TRANS/WP.29/GRRF/2002/19  
1 July 2002

World Forum for Harmonization of Vehicle Regulations (WP.29)

PROPOSAL FOR DRAFT AMENDMENTS TO REGULATION No. 109

(Retreaded pneumatic tyres for commercial vehicles)

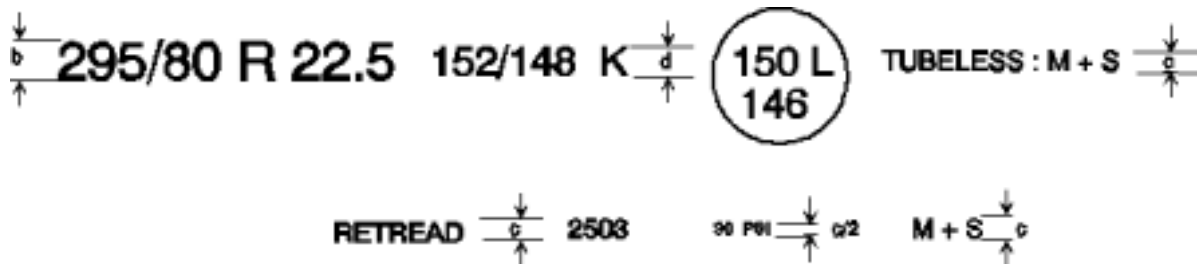
Insert a new paragraph 2.23.1., to read:

"2.23.1 "Tyre to rim fitment configuration" means the type of rim to which the tyre is designed to be fitted. In the case of non-standard rims this will be identified by a symbol applied to the tyre, for example, "A".
